ADDENDUM NO. 7

Project Name: Sandridge Golf Club New Clubhouse

ITB Number: 2024029

SHEET NAME
WALL SECTIONS

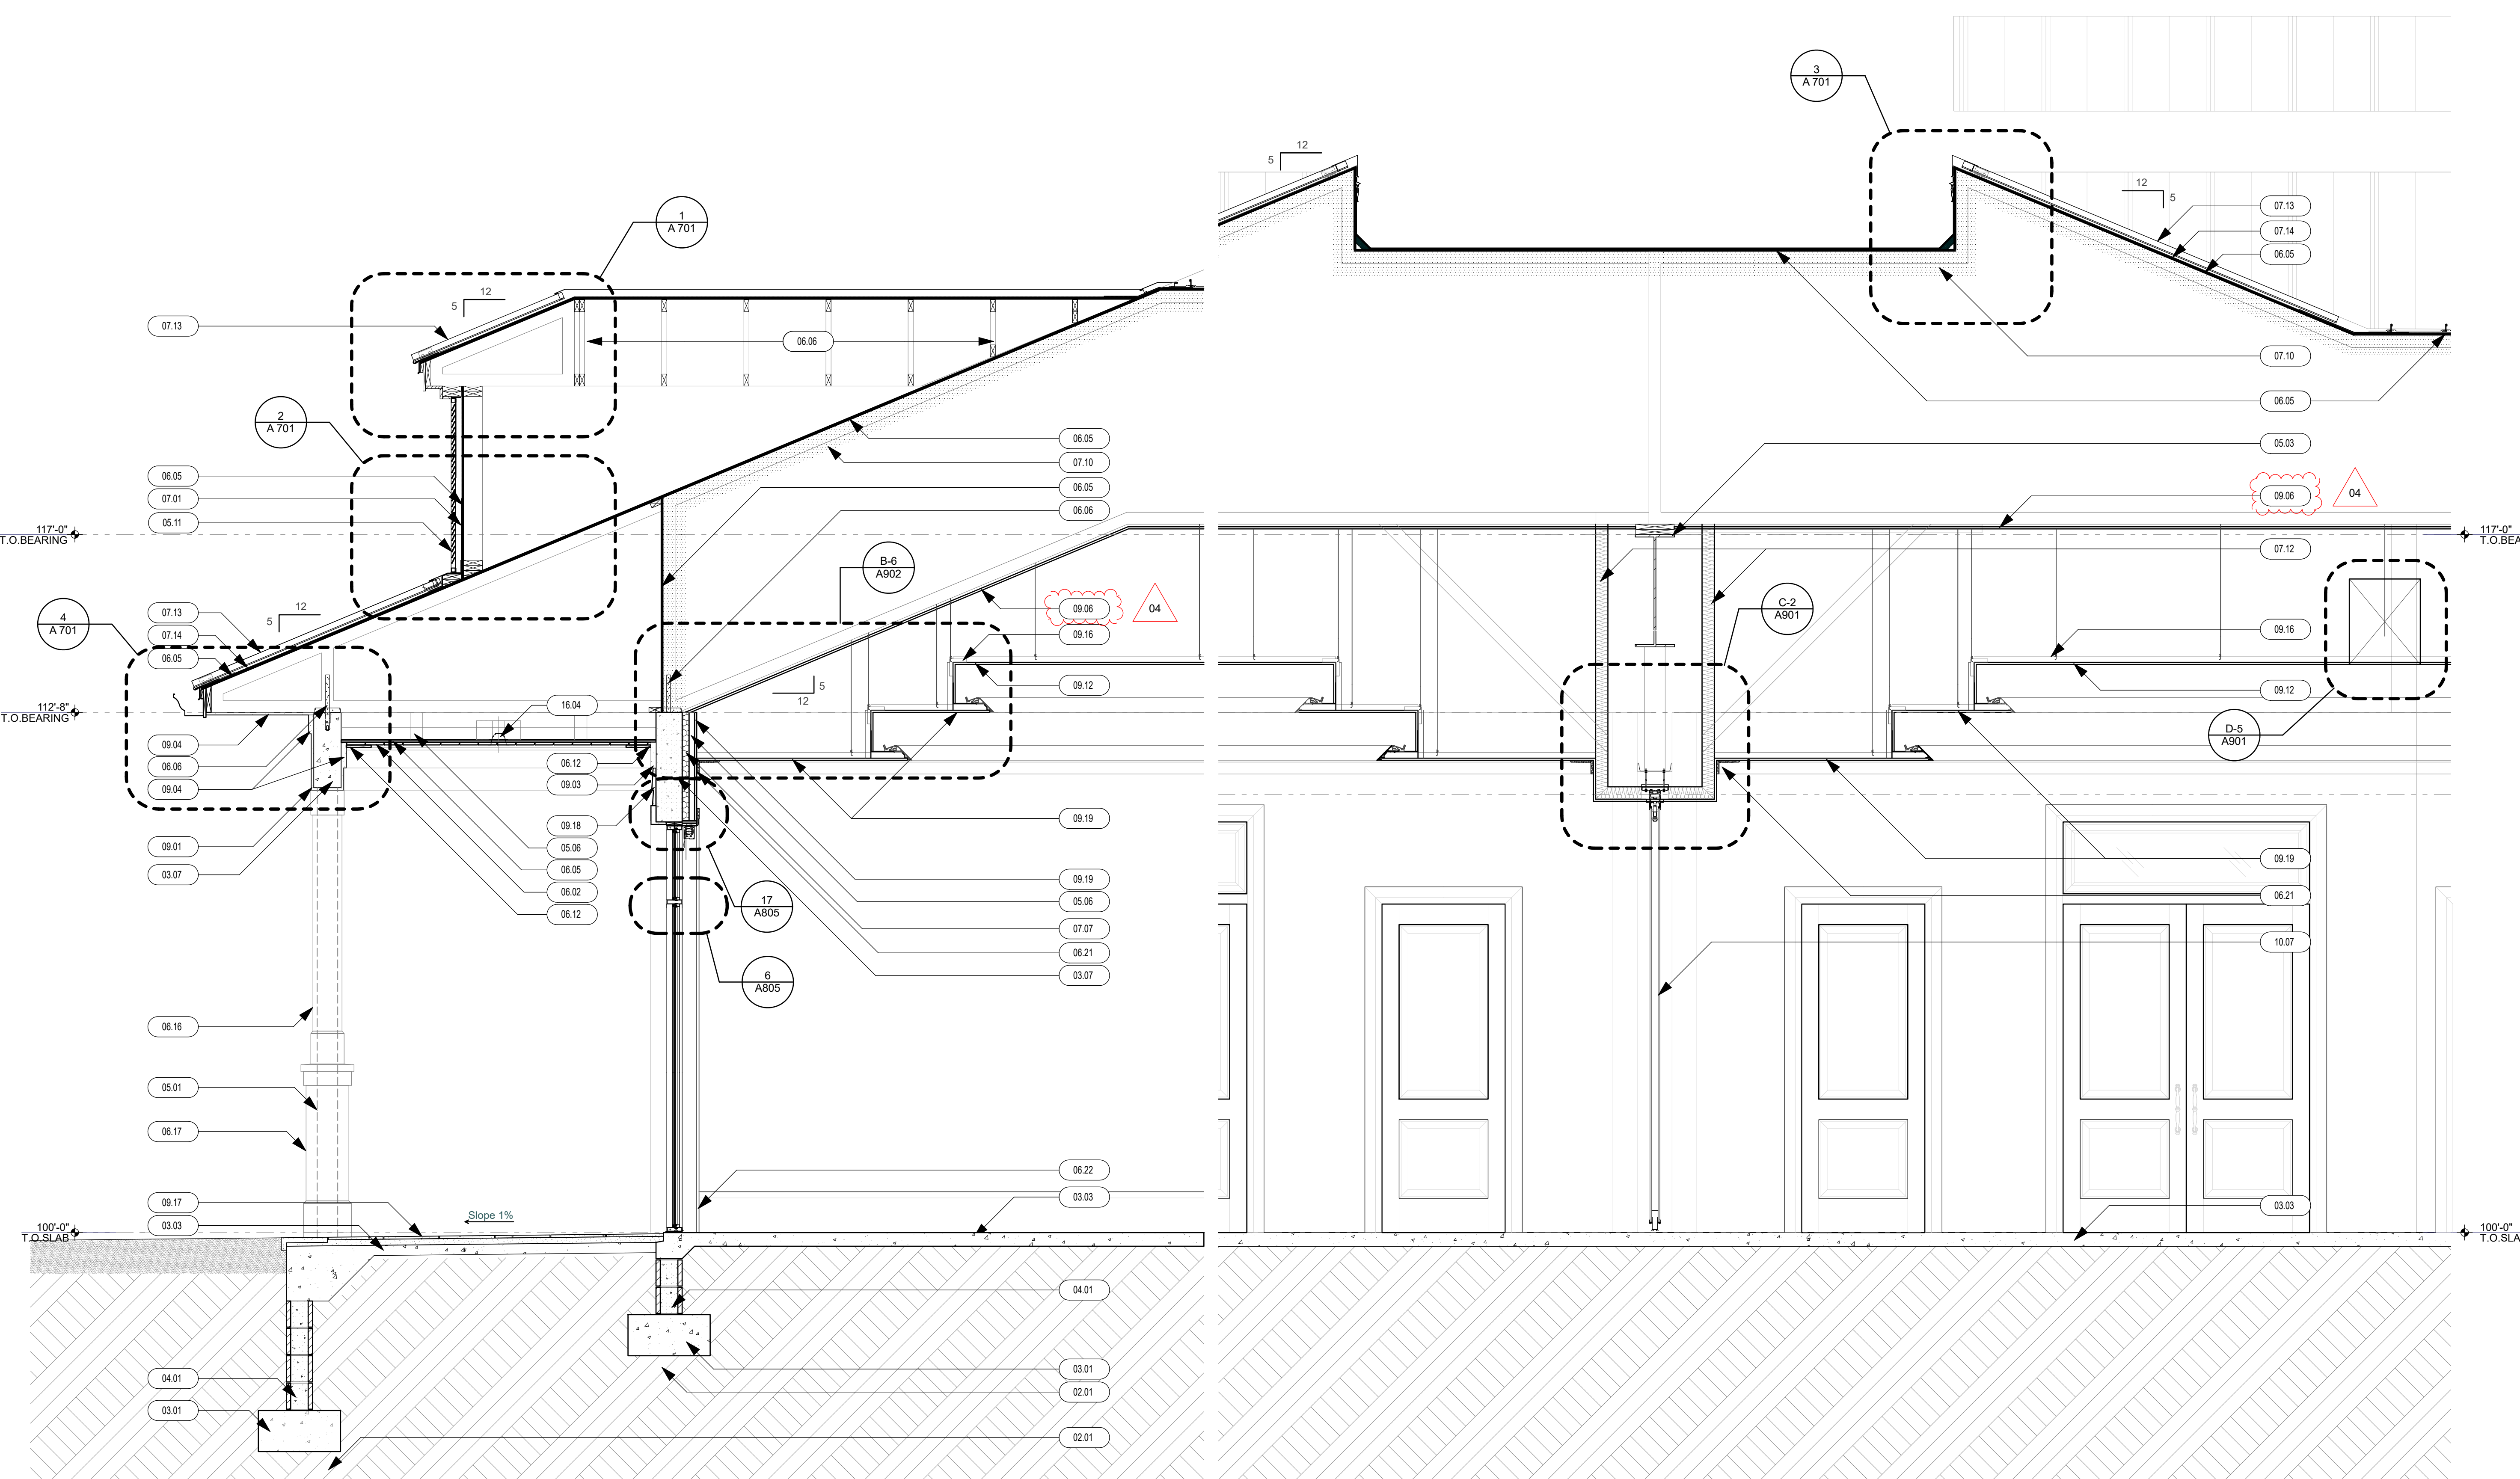
- Note 17 on the RCP drawings refers to a 2 HR ceiling assembly. I have not been able to find the location of the rated assembly. Furthermore, there are details showing plywood on the underside of the trusses (A411) and others showing GWB (A902). Can we get a clarification as to the extent of the sheathing on the bottom chord (interior of building) and a location for the 2 HR ceiling?

Response: There is no 2 HR ceiling lid on the bottom of the trusses on the project. Sheet A411 keynote 06.05 is revised to 09.06. This is an acoustic drywall lid on the bottom of the trusses in the banquet rooms only. The details on A902 reflect this accurately. Plywood is only used on the interior of the building as a backer to attach finished material like t&g to the ceiling. Refer drawings for details.
- M000 Note #17 Specifies Programmable Thermostats (stand Alone)
